FINAL MITIGATION PLAN

BANNER FARM MITIGATION SITE

Henderson County, NC
NCDEQ Contract No. 7530
DMS ID No. 100062

Re: NCIRT Review and USACE Approval of the NCDMS Banner Farm Mitigation Site /
Henderson Co./ SAW-2018-01153/ NCDMS Project # 100062

Figure 9 Discharge Analysis
 Banner Farm Mitigation Site
 French Broad River Basin 06010105
 Henderson County, NC

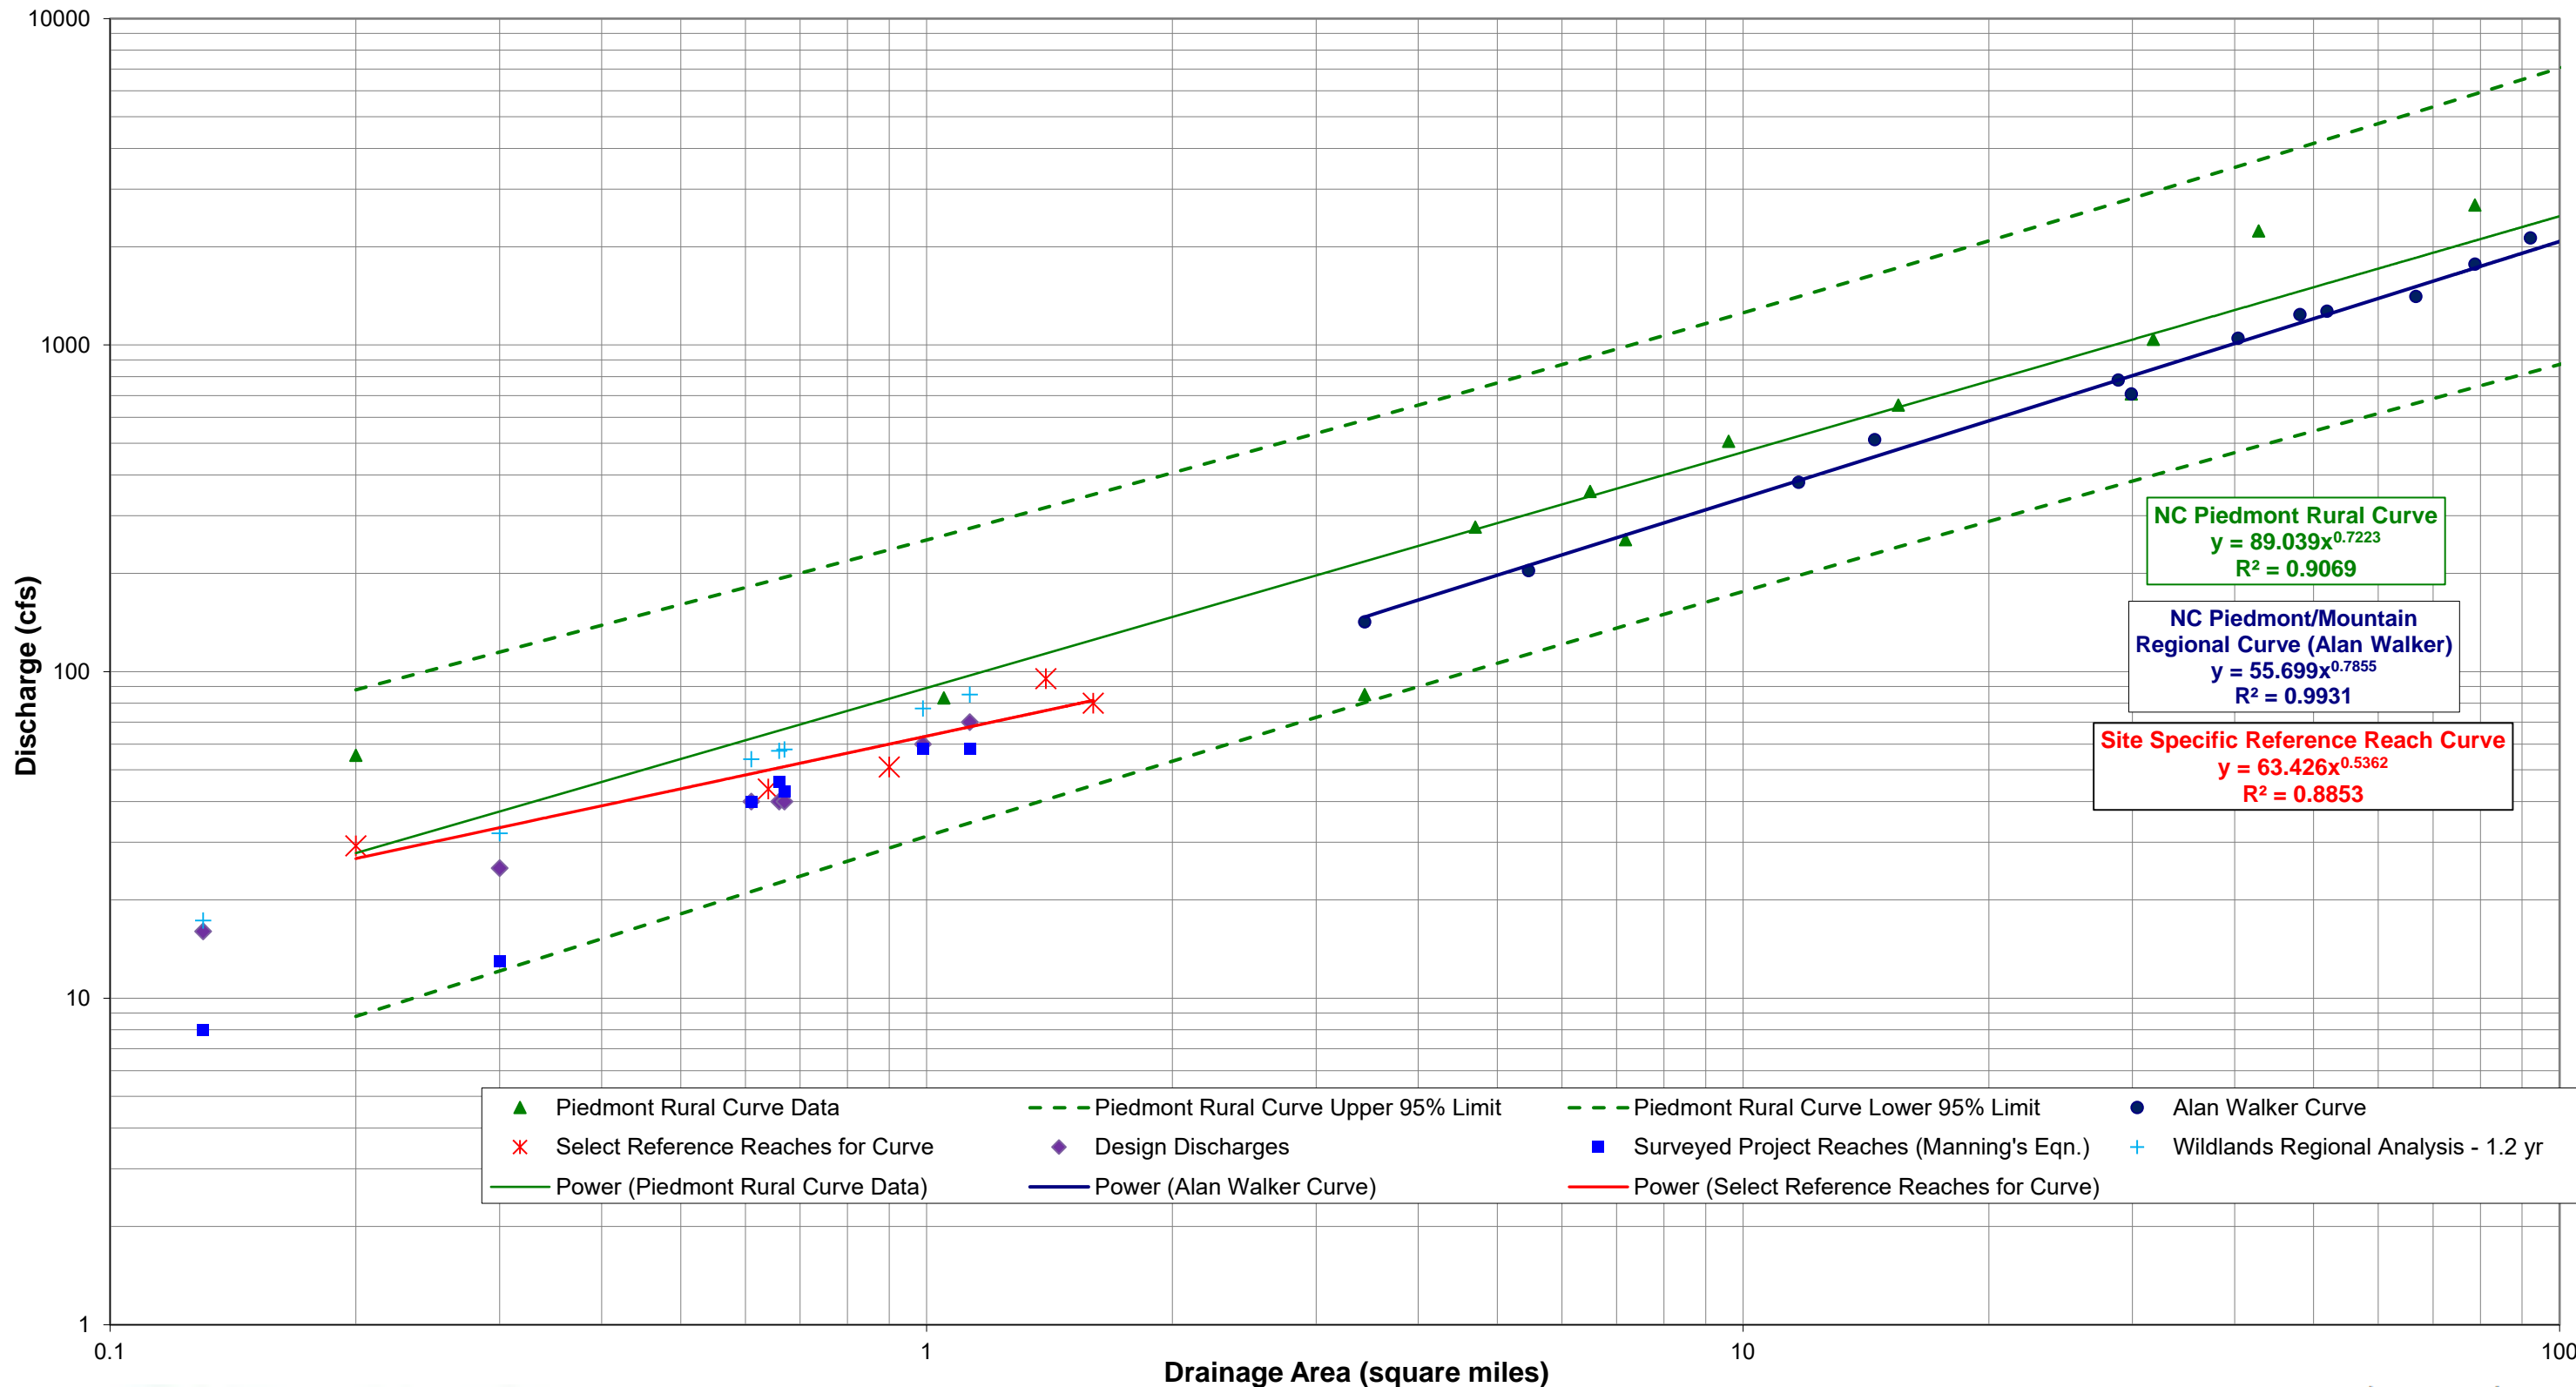
8.4.2 Regional Flood Frequency Analysis: Last paragraph in section indicates that the Wildlands regional flood frequency analysis 1.2-year predictions are plotted on Figure 9. This analysis is not currently plotted on Figure 9. Please update.

- **8.4.2 Regional Flood Frequency Analysis:** *Last paragraph in section indicates that the Wildlands regional flood frequency analysis 1.2-year predictions are plotted on Figure 9. This analysis is not currently plotted on Figure 9. Please update.*

- Figure 9 was updated with the 1.2-year predictions from Wildlands' regional flood frequency analysis.
- **Page 30, Table 15:** *The table indicates bankfull flows will be moving most particle sizes on all reaches. Is this the intention of design or are the ranges due to the low and high estimates from two different methods? Please be a bit more specific regarding sediment competence estimates and explanation.*

Figure 11 Monitoring Components Map
Banner Farm Mitigation Site
French Broad River Basin 06010105

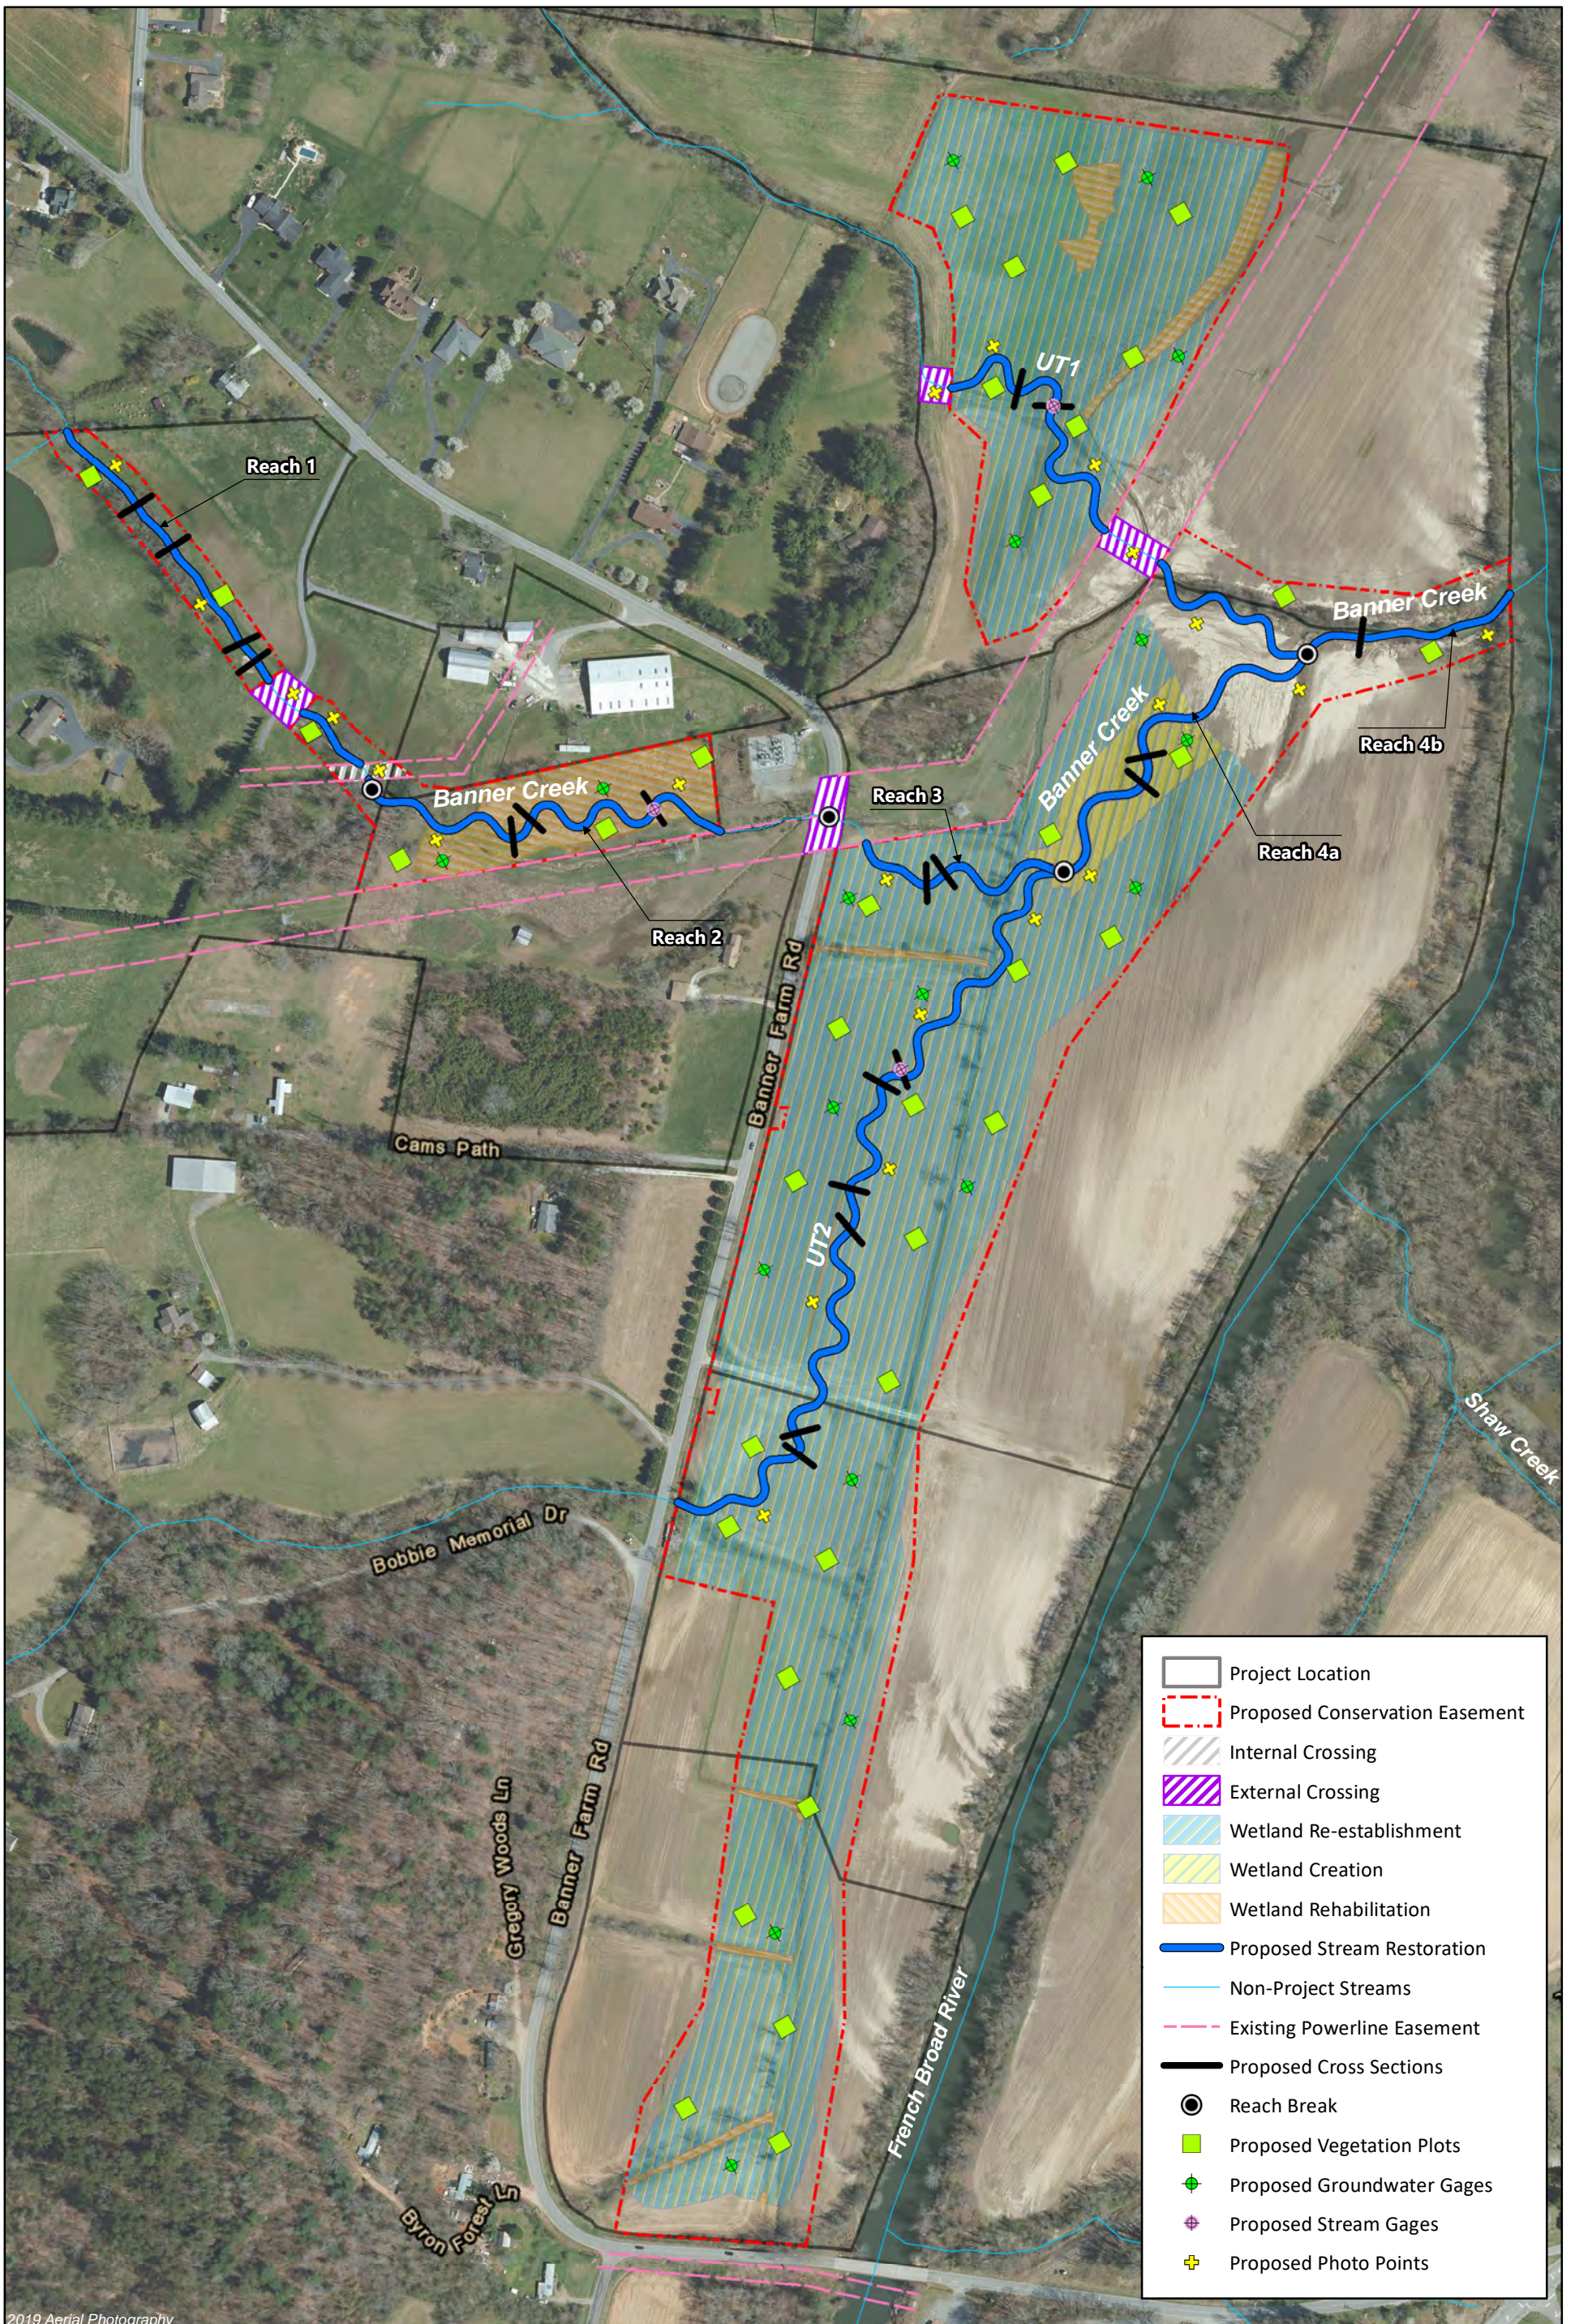
19. Figure 10 – DWR requests one additional gauge and five groundwater gauge relocations – see figure markup (attached).
20. Appendix 7 – Please include the coordinates for the Sierra Nevada well location.

19. Figure 10 – DWR requests one additional gauge and five groundwater gauge relocations – see figure markup (attached).

2. Figure 6 shows existing groundwater gages, while Figure 11 shows gages in different locations. Will the existing gages still be monitored, or just moved during construction? It would be beneficial to have gages in approximately the same areas to compare pre and post construction data and justify functional uplift.

Additional monitoring photo point locations have been added to proposed crossings. Figure 11 Monitoring Component Map and Table 19 have been updated.

Wildlands updated Figure 11 with the groundwater gages per the supplied Figure 11 provided with the comments. Please see updated Figure 11 Monitoring components map. During as-built monitoring device installation, Wildlands will use best professional judgment to ensure the groundwater gage locations sufficiently define the boundary and are representative of the proposed wetland restoration areas.
